The Republic, Mayfield Manchester
Planning Addendum Report
0197_MAY-MCO-M01-XXXX-RP-A-090080
Rev: P03
Ref: A283-10.01-148
November 2024

1.0 Planning Addendum

1.1 Introduction

Massing (TRM-09)

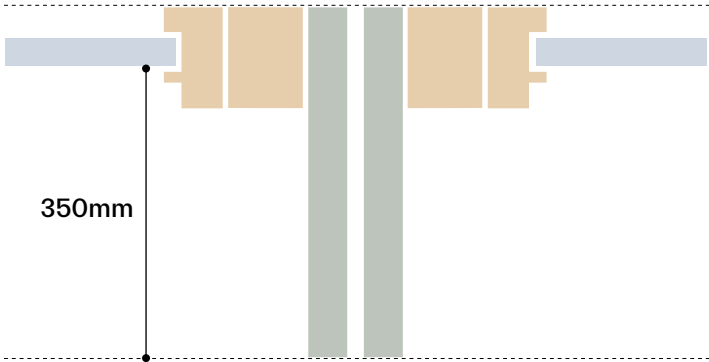
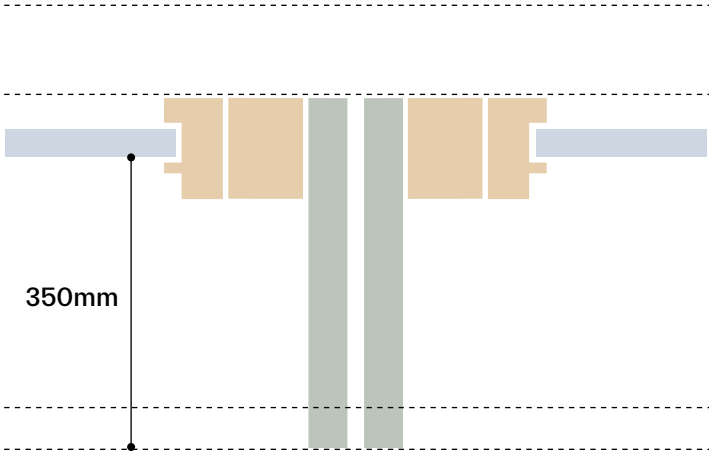
Massing is simplified with an additional step to the north removed, the building massing has improved clarity, along with a significant improvement in building efficiency and embodied carbon performance

Larger Loggias align with those included on upper floors, continue to provide a consistent approach to the chamfered facades of the building, and provide additional external amenity space to all office floor levels, further increasing connectivity to Mayfield Park

The delivery of the facade as a unitised system provided significant opportunity to improve and maintain quality of the finishes to the building envelope as a whole. The sophisticated articulation of individual elements will be all the more effective for constructing in this manner. The proposed facade system does not impact the architectural design intent or external appearance of the facade of the consented scheme with fin depths being maintained.

2.1 Ground Floor Plan

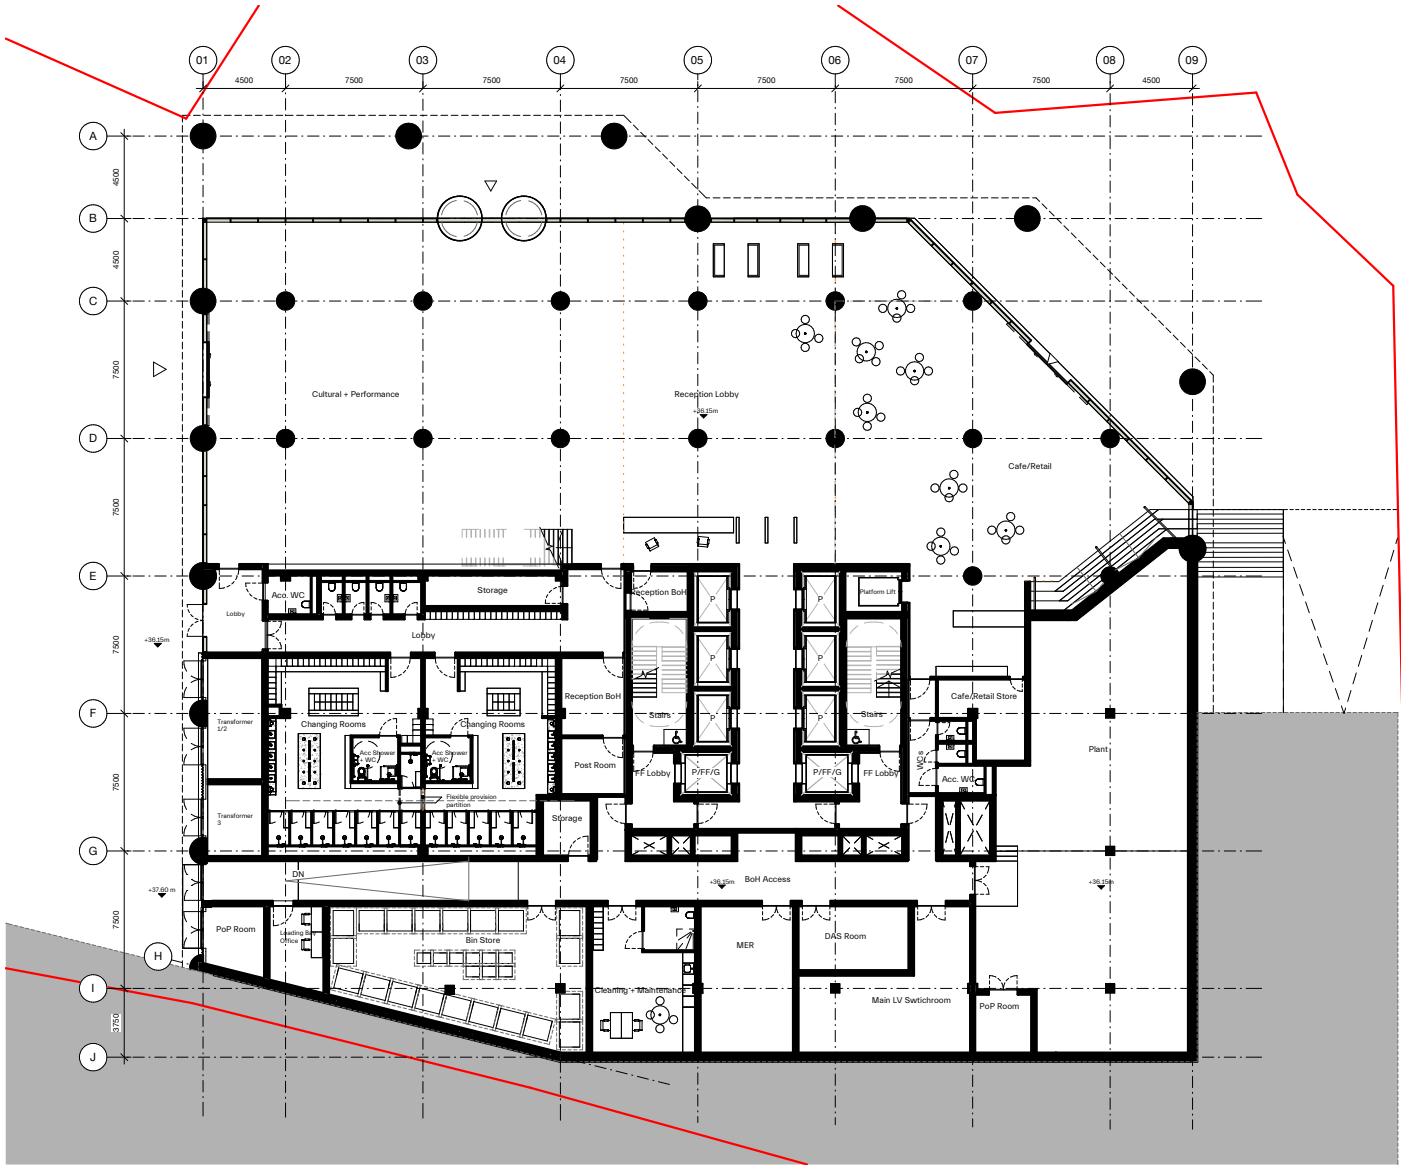
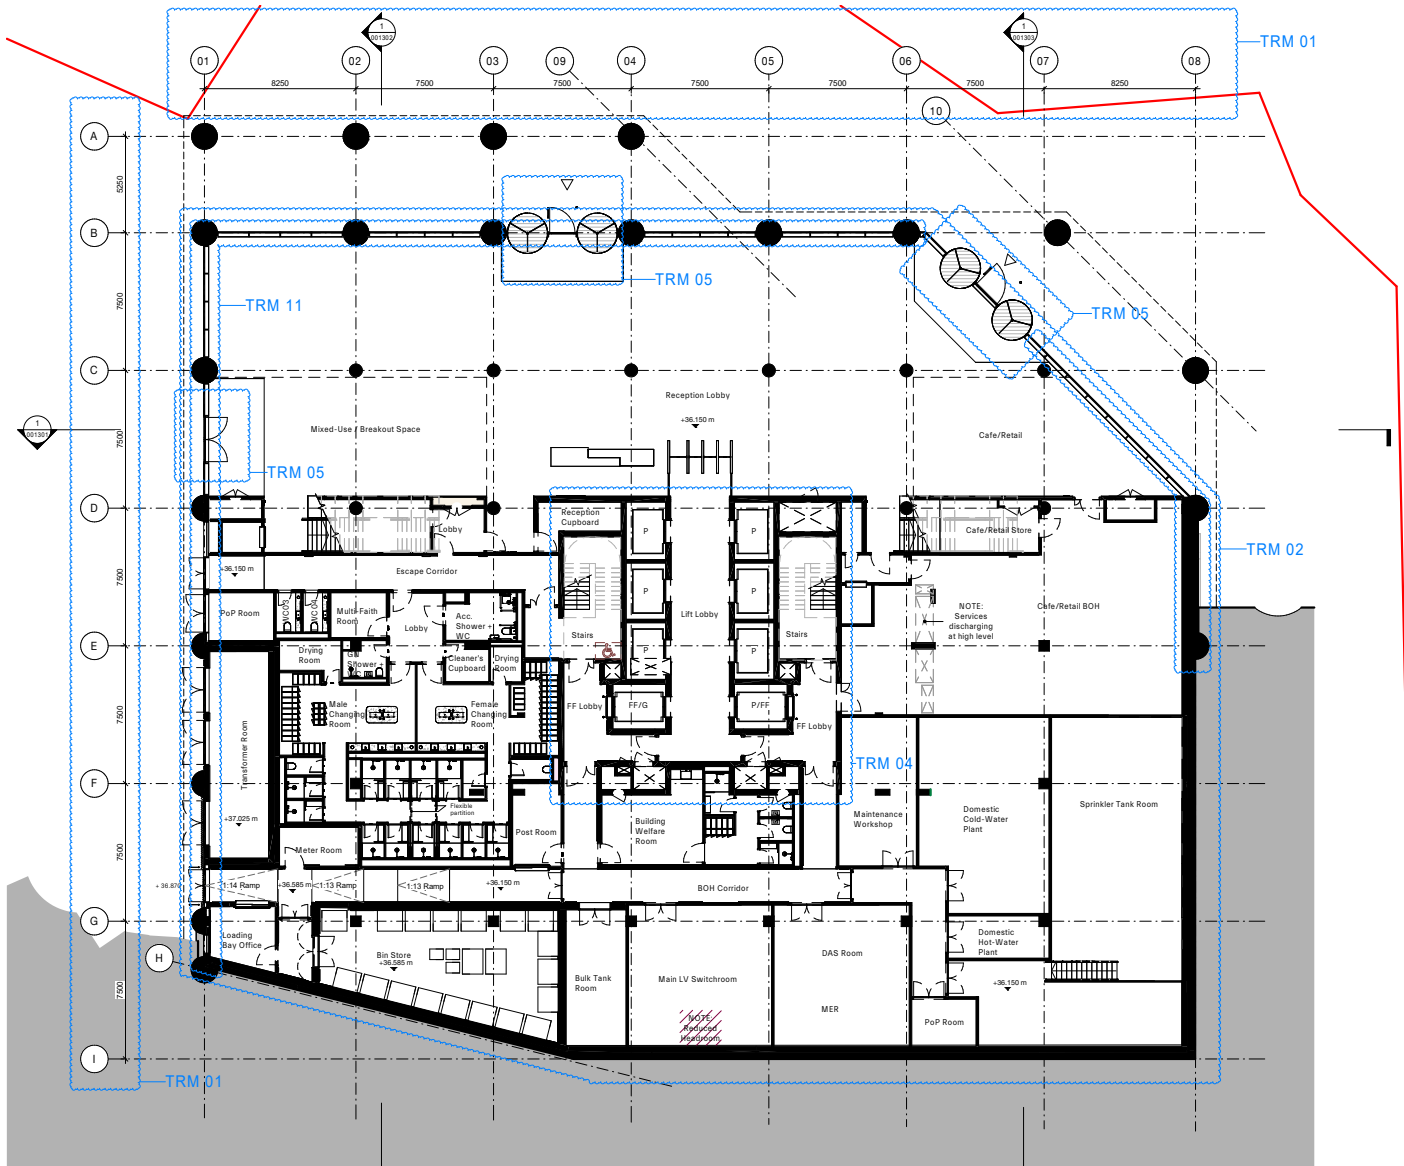
- + TRM 01 - Structural Grid
- + TRM 02 - Ground Floor Reception & BOH
- + TRM 04 - Core Position
- + TRM 05 - Ground Floor Entrance
- + TRM 11 - Facade Development

2.2 Mezzanine Floor Plan

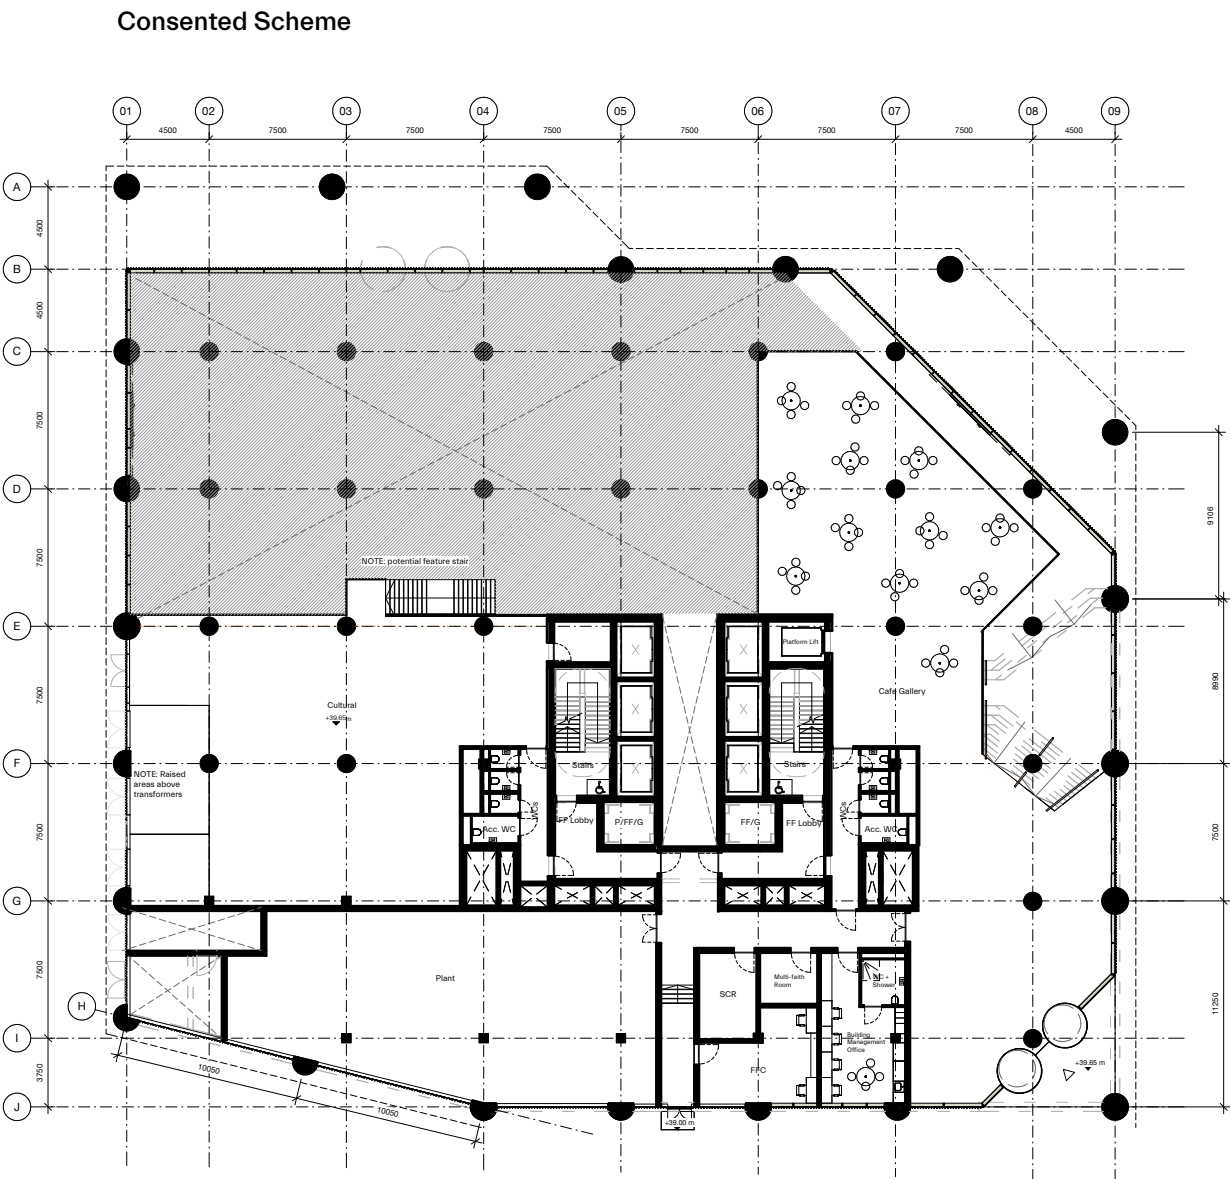
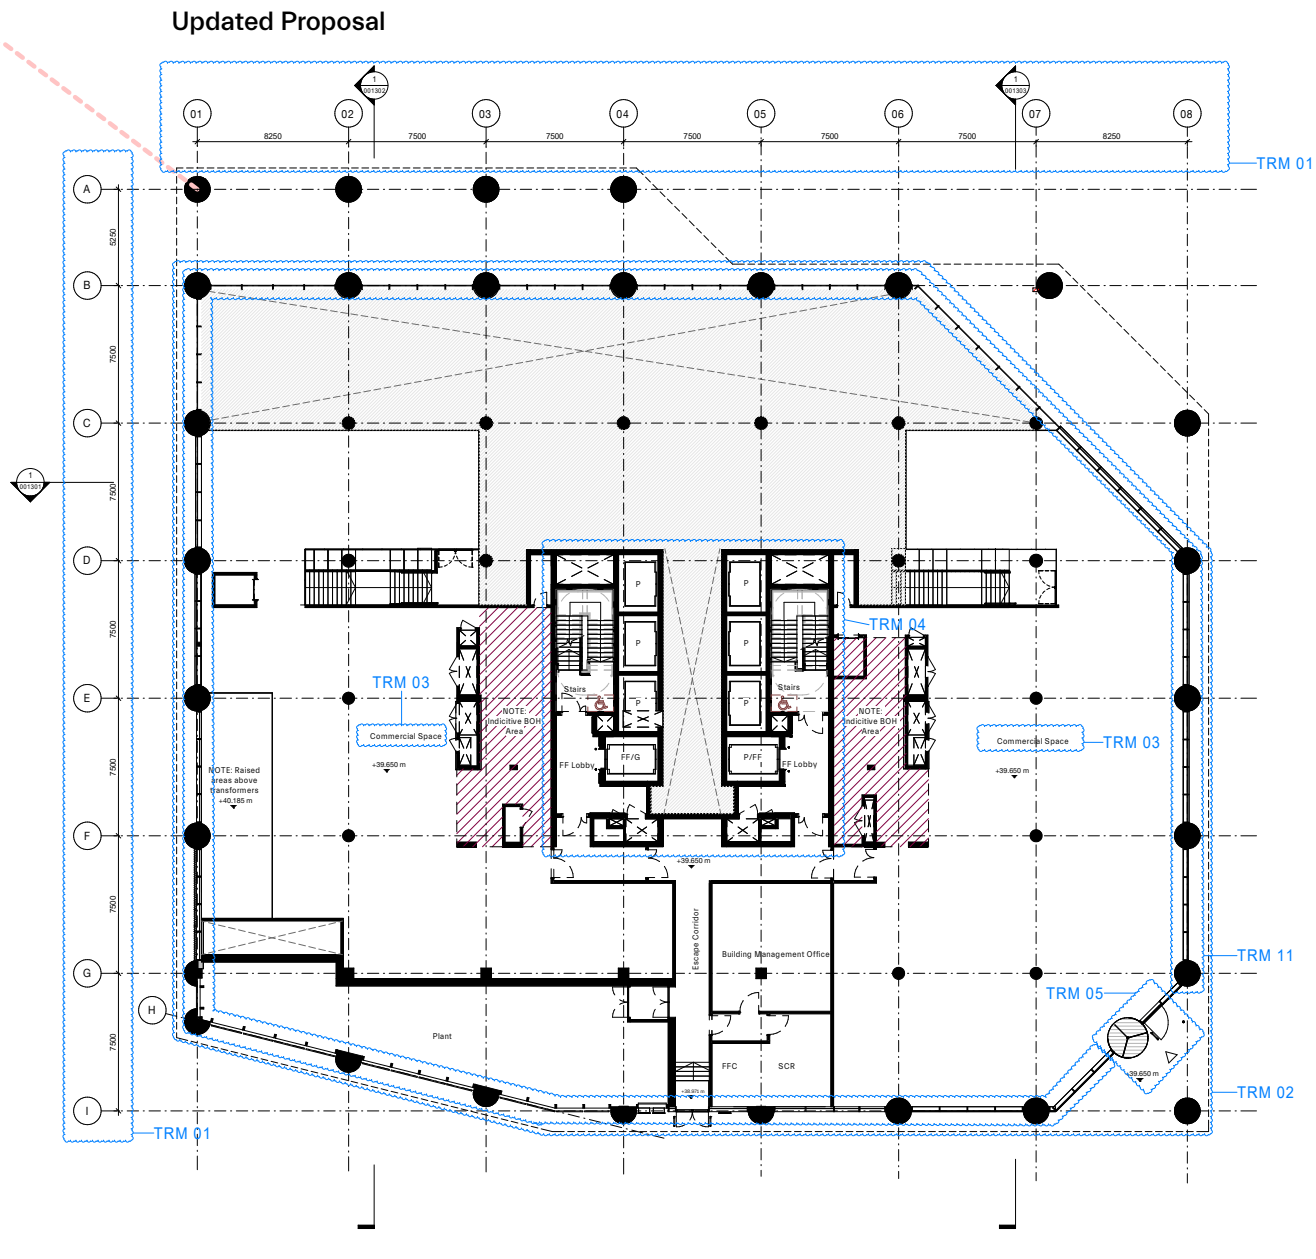
- + TRM 01 - Structural Grid
- + TRM 02 - Ground Floor Reception & BOH
- + TRM 03 - Internal Uses
- + TRM 04 - Core Position
- + TRM 05 - Ground Floor Entrance
- + TRM 11 - Facade Development

2.3 First Floor to Fourth Floor Plan

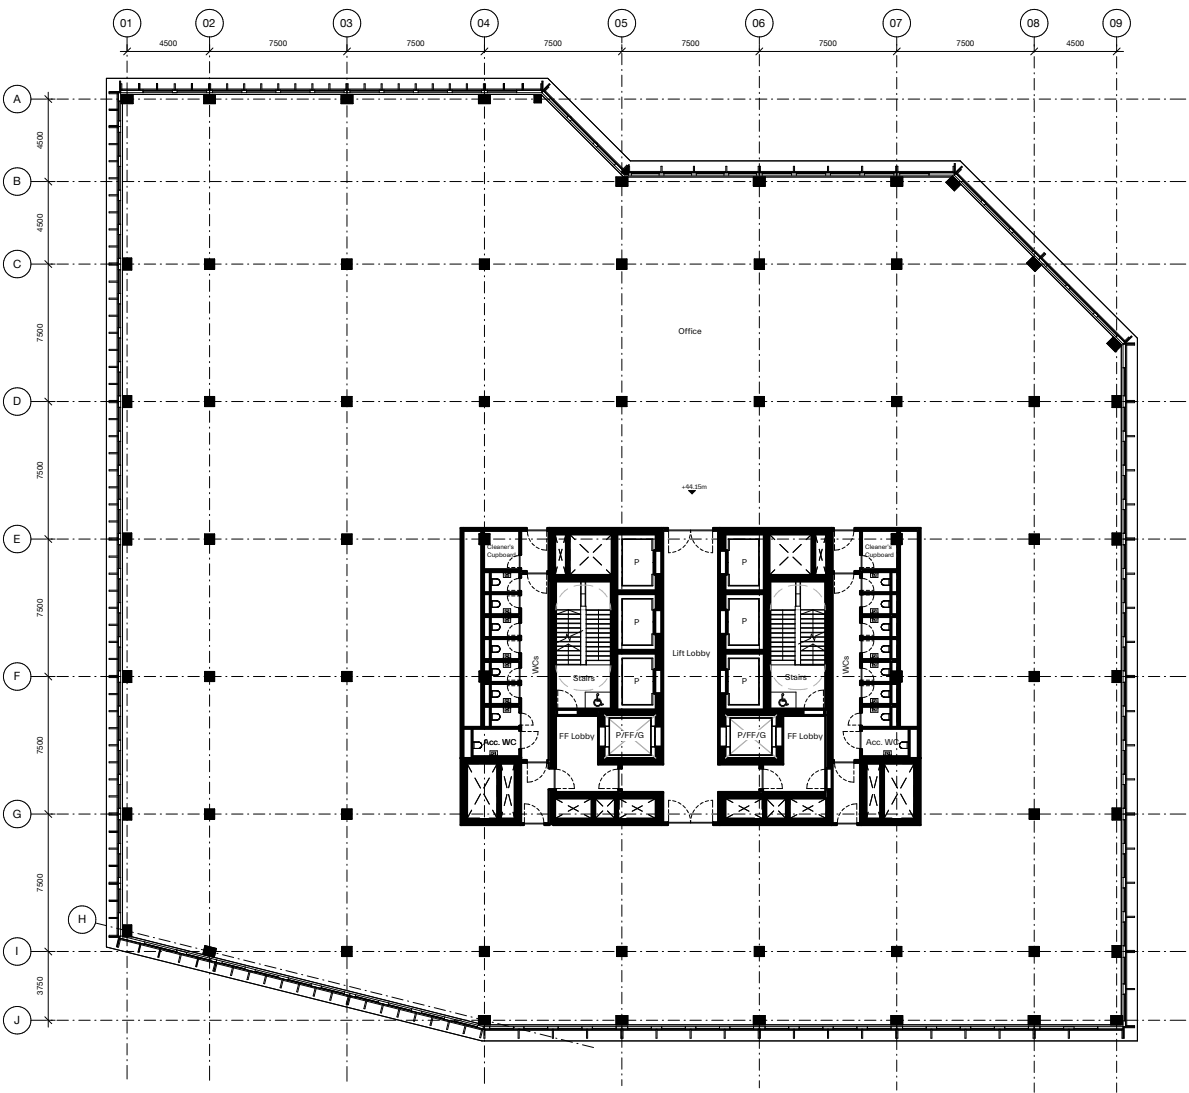
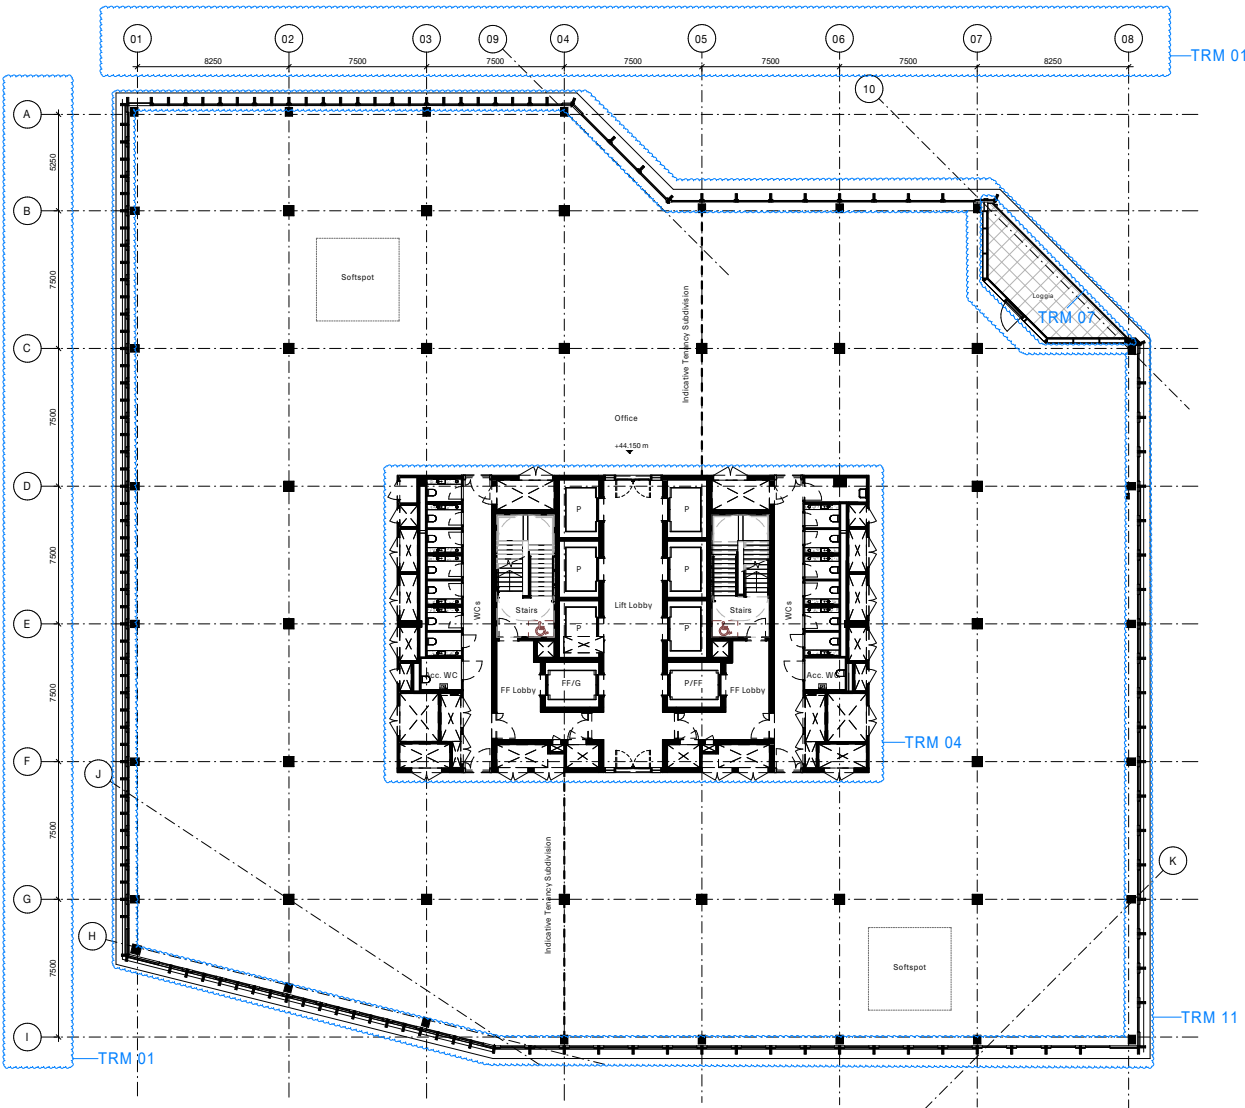
- + TRM 01 - Structural Grid
- + TRM 04 - Core Position
- + TRM 07 - Loggia
- + TRM 11 - Facade Development
